No. EC120-24-015

SERVICE BULLETIN

ELECTRICAL POWER - Electrical master box

Separation of the direct battery distribution from the electrical master box

Figure 3

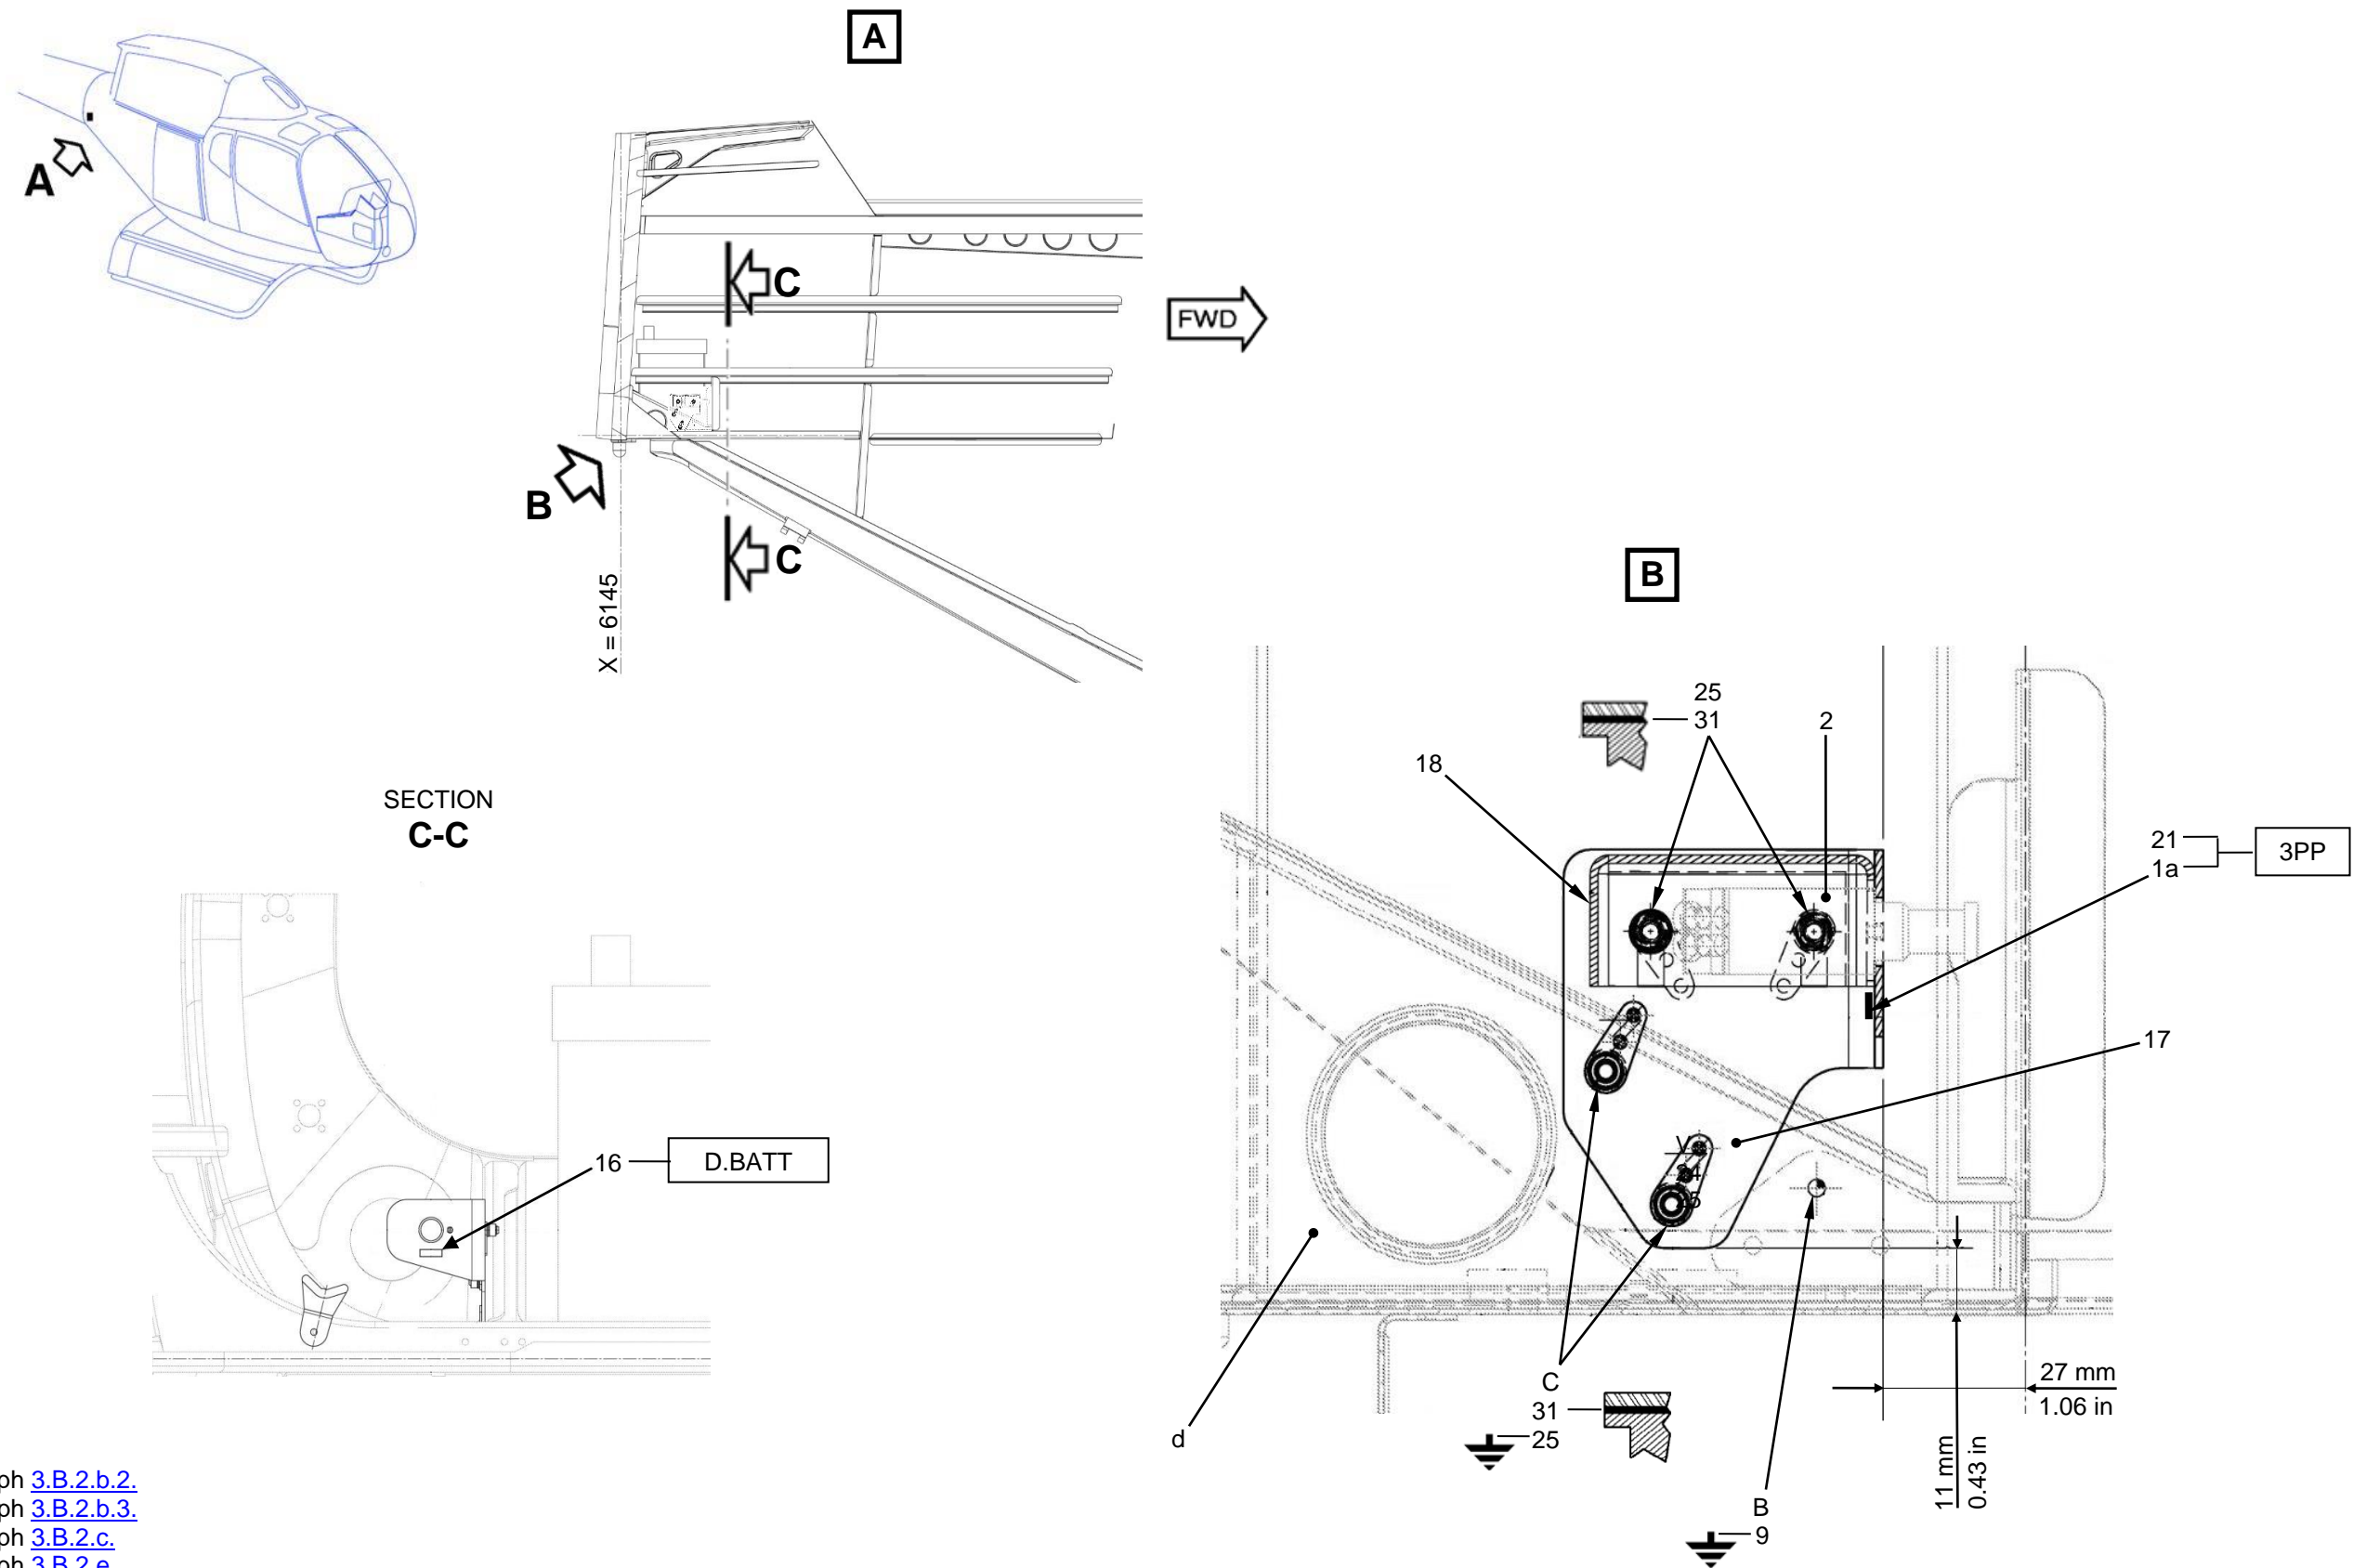
- Position breaker support assembly (17) as shown.
- Mark the fixation holes (C) on the RH web (d).
- Remove the breaker support assembly (17).
- Drill the fixation holes (C) on the RH web (d) using a 4.2 mm (0.165 in) diameter drill.

- Deburr and clean the fixation holes (C).
- Perform touch up on the fixation holes (C) with the chemical conversion material (30) as per Work Card 20-04-04-403 (MTC) (not shown in figure).
- Install the breaker support assembly (17) with bolts (31) and washers (25):
 - . apply interposition sealant (19) on the bolts (31) as per Work Card 20-05-01-227 (MTC).
- Perform touch up on the bolts (31) with the P05 epoxy primer (28) as per Work Card 20-04-05-402 (MTC) (not shown in figure).

- Bond labels "3PP" (1a) or (21) as shown in DETAIL B:
 - . clean the concerned area.
- Apply a layer of varnish (15) over the labels "3PP" (1a) or (21) as per Work Card 20-02-07-403 (not shown in figure).
- Temporarily install the bolts (31) and the washers (25) on the breaker support assembly (17) (DETAIL B):
 - . leave a gap of approximately 2 mm between the washers (25) and the breaker support assembly (17).
- Install the circuit breaker (2) on the breaker support assembly (17).
- Bond label "D.BATT" (16) as shown in SECTION C-C:
 - . clean the concerned area.
- Apply a layer of varnish (15) over the label "D.BATT" (16) as per Work Card 20-02-07-403 (MTC) (not shown in figure).

- Install breaker cover (18) on the breaker support assembly (17).
- Fully tighten the bolts (31):
 - . apply interposition sealant (19) on the bolts (31) as per Work Card 20-05-01-227 (MTC).
- Perform touch up on the bolts (31) with the P05 epoxy primer (28) as per Work Card 20-04-05-402 (MTC) (not shown in figure).

Figure 4

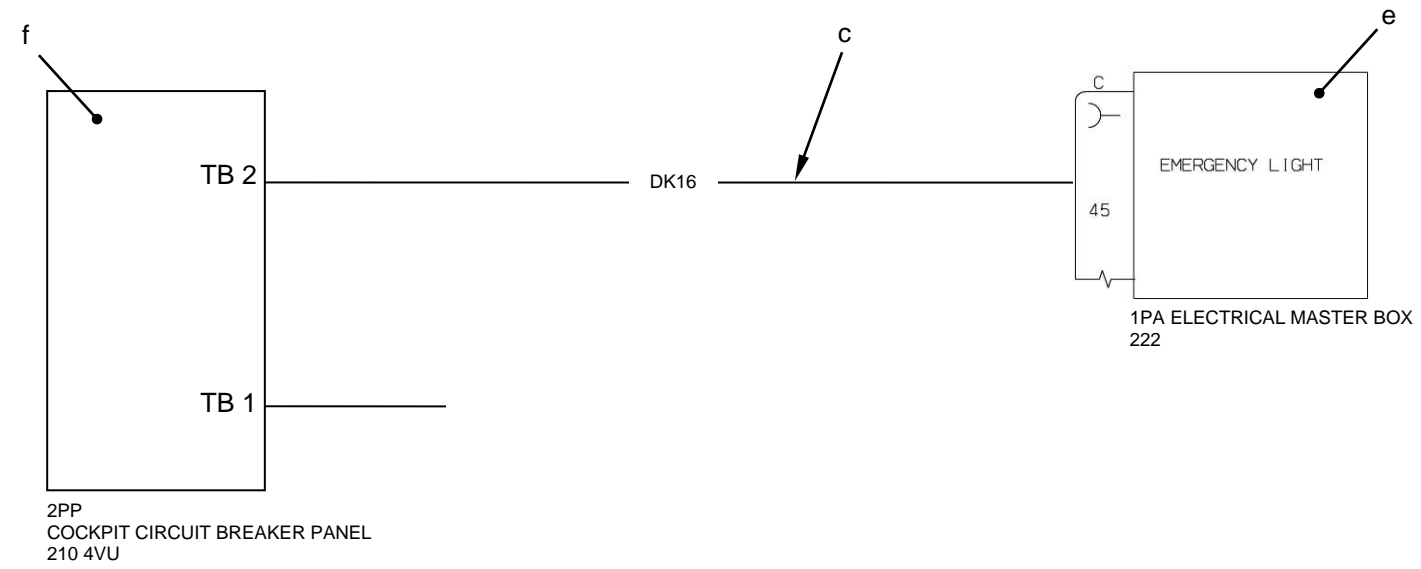
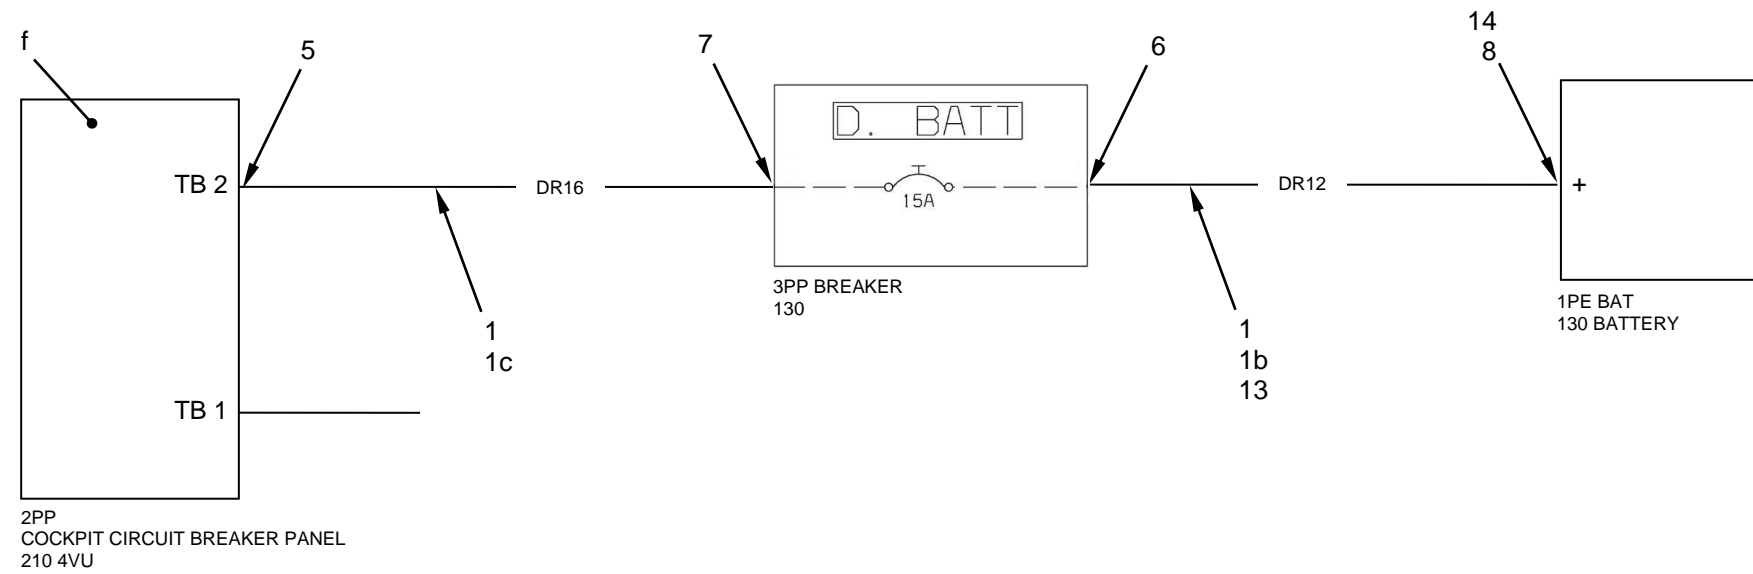
- Disconnect cable (c) from electrical master box (e) ([Figure 4](#) or [Figure 5](#), PRE SB).
- Connect cable (1b) of set of wires and markers (1) with terminals (6) and (8) as per [Figure 4](#) or [Figure 5](#), POST SB.
- Perform a continuity test of the modified wiring.
- Install the silicone sheath (14) on the terminal (8) at battery side and the convoluted sheath (13) on the whole cable (1b).

- Remove cockpit circuit breaker panel (f) as per Task 24-61-02, 4-1 (AMM) ([Figure 4](#), PRE SB).
 - Disconnect and discard the cable (c).
 - Connect cable (1c) of the set of wires and markers (1) with terminals (5) and (7) as per [Figure 4](#), POST SB:
 - . do not bend the terminal (5),
 - . if the terminal (5) was bent during compliance with revision 0 of this Service Bulletin, replace the terminal (5) with a new one.
 - Perform a continuity test on the wiring.
 - Install the cockpit circuit breaker panel (f) as per Task 24-61-02, 4-1 (AMM).
- 3.B.2.d.3. Modification of the wiring between "3PP" circuit breaker and cockpit circuit breaker panel (P/N: 7050A4240018) ([Figure 5](#) and [Figure 6](#))

Figure 5

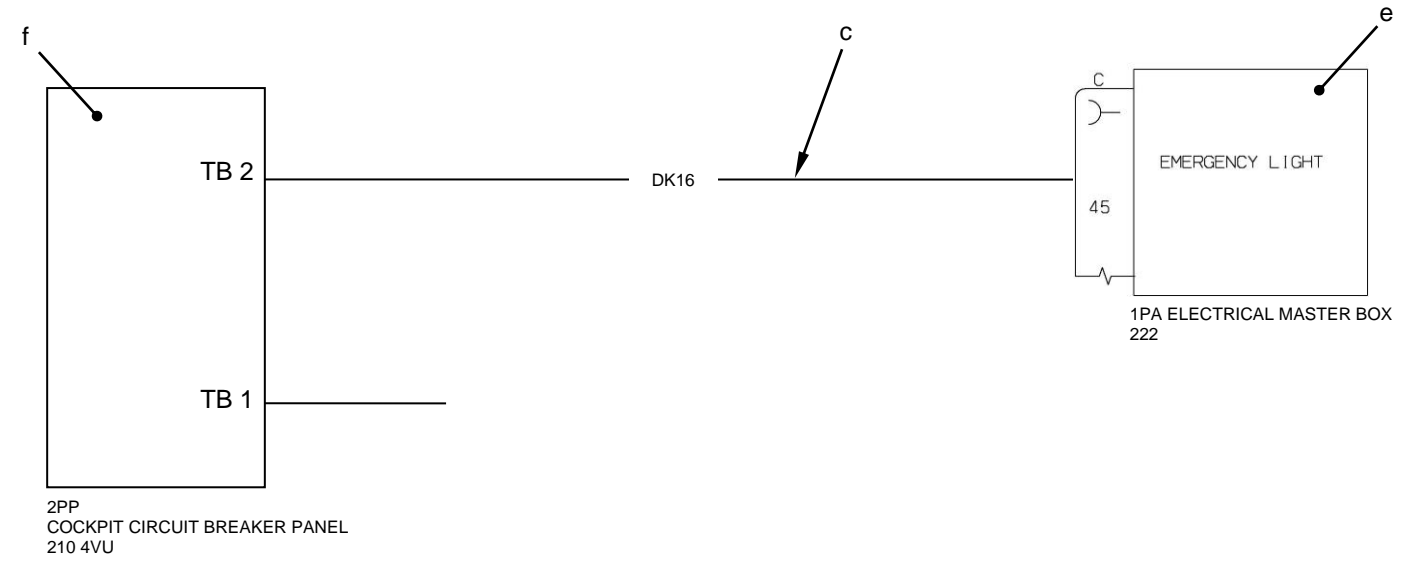
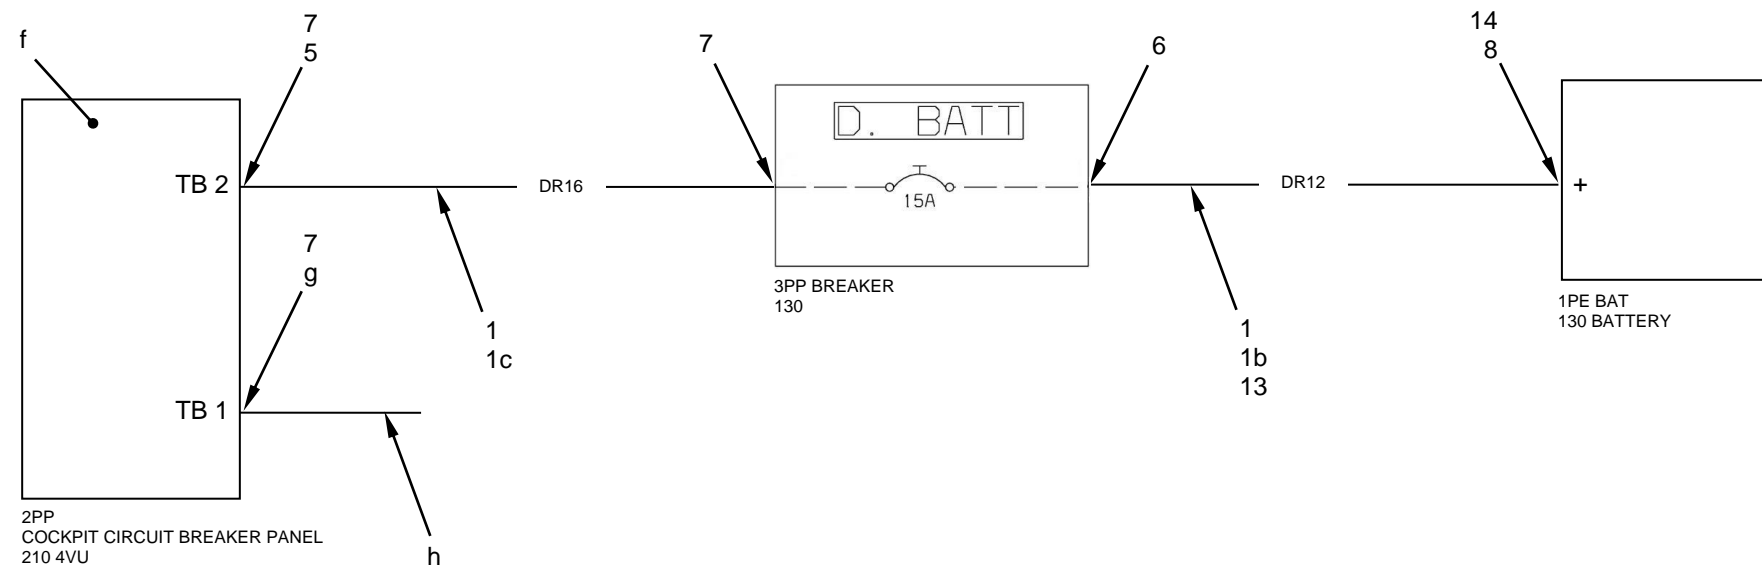
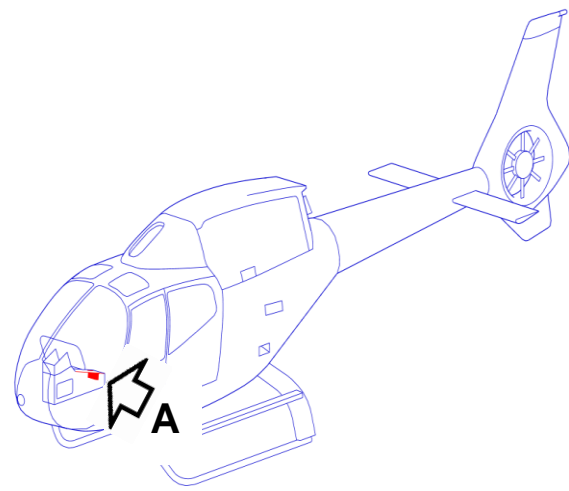
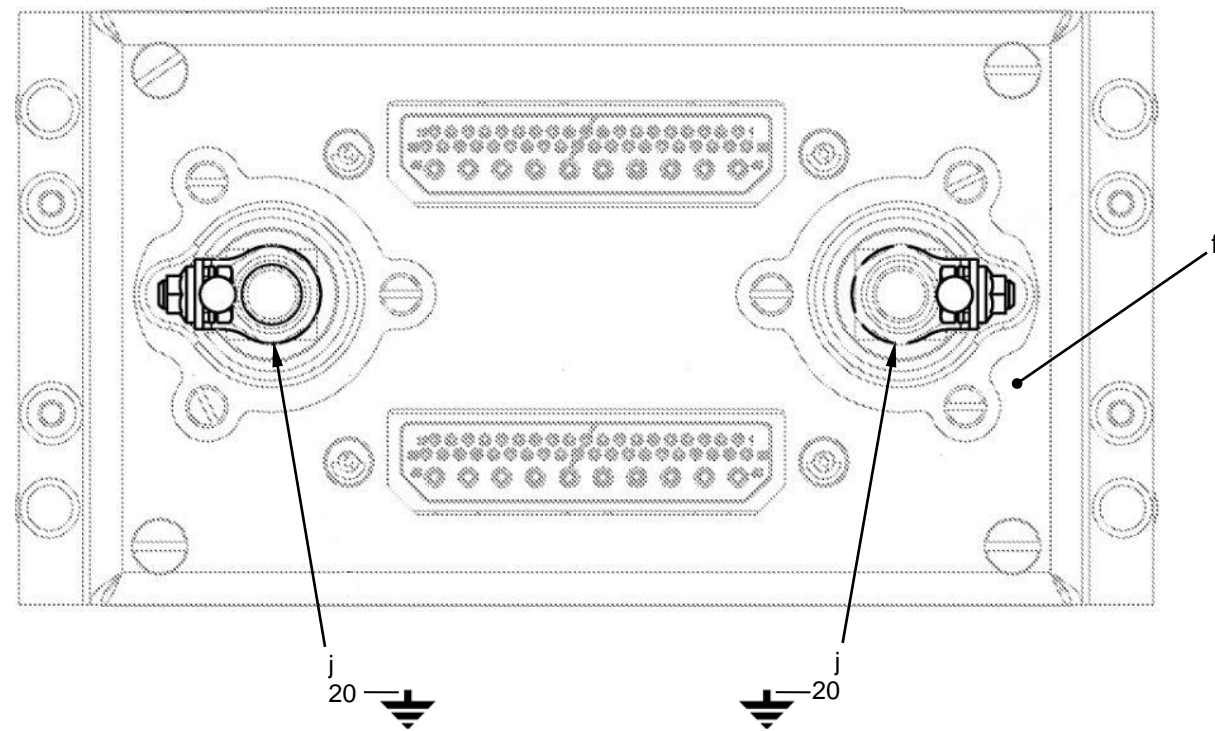
- Remove the cockpit circuit breaker panel (f) as per Task 24-61-02, 4-1 (AMM) ([Figure 5](#), PRE SB).
- Disconnect and discard the cable (c).
- Install bus strips (20) on the cockpit circuit breaker panel (f) with its existing hardware (j) ([Figure 6](#), DETAIL B).

- Connect the cable (1c) of the set of wires and markers (1) with the terminals (7) as per [Figure 5](#), POST SB:
 - . for helicopters that have complied with revision 0 of this Service Bulletin, cut and discard the terminal (5) on the cable (1c).

- Disconnect cable (h) from the circuit breaker panel (f).
- Cut and discard terminal (g).
- Install the terminal (7) on cable (h).
- Perform a continuity test on the wiring.

Figure 6

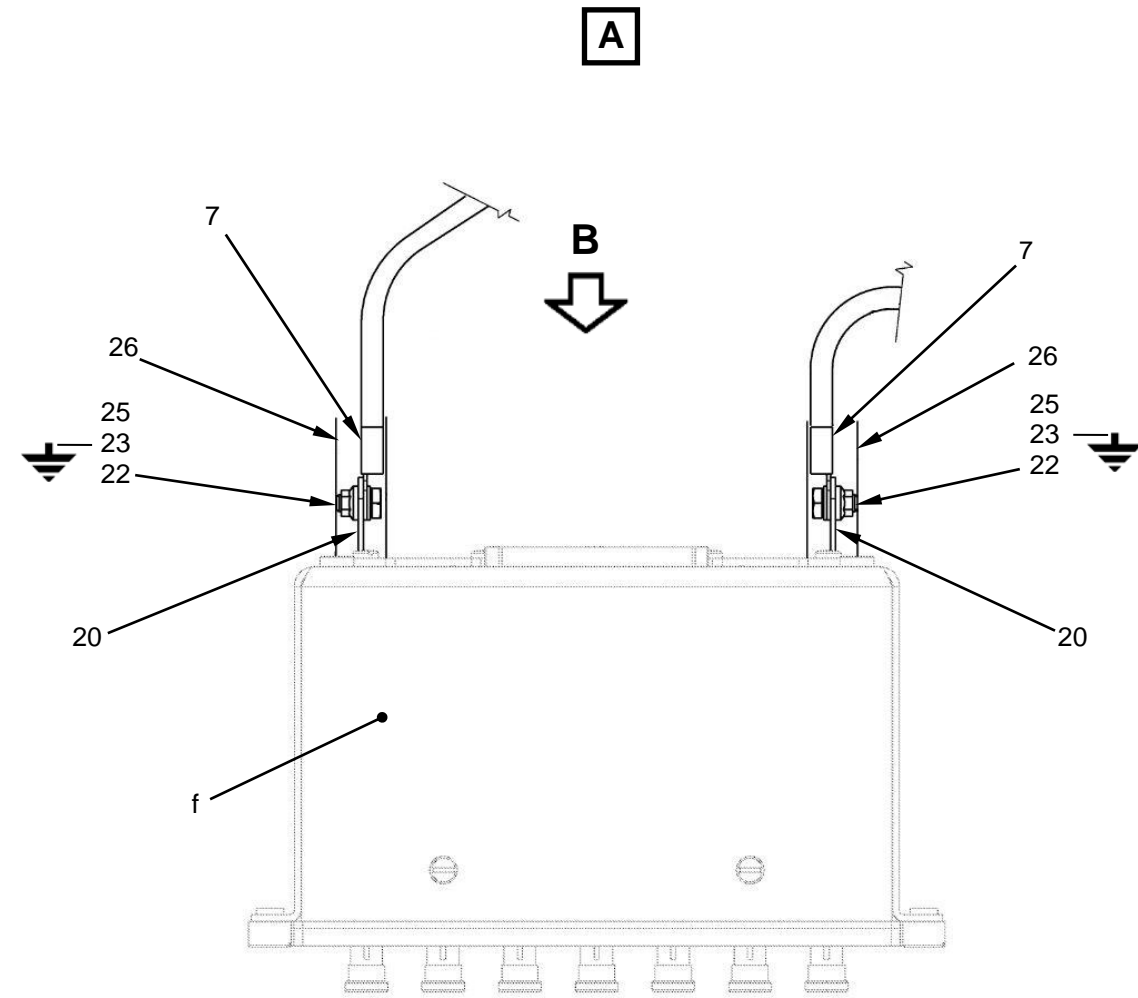
- Install the terminals (7) on the bus strips (20) with nuts (22), bolts (23), washers (25) and sleeve (26) ([Figure 6](#), DETAIL A):
 - . apply a layer of grease (27) on the bolts (23) (not shown in figure),

- . apply a layer of protection (29) on the bus strips (20), the nuts (22), the bolts (23) and the washers (25) (not shown in figure),
 - . shrink sleeve (26) over the bus strips (20), the nuts (22), the bolts (23) and the washers (25) ([Figure 6](#), DETAIL A).
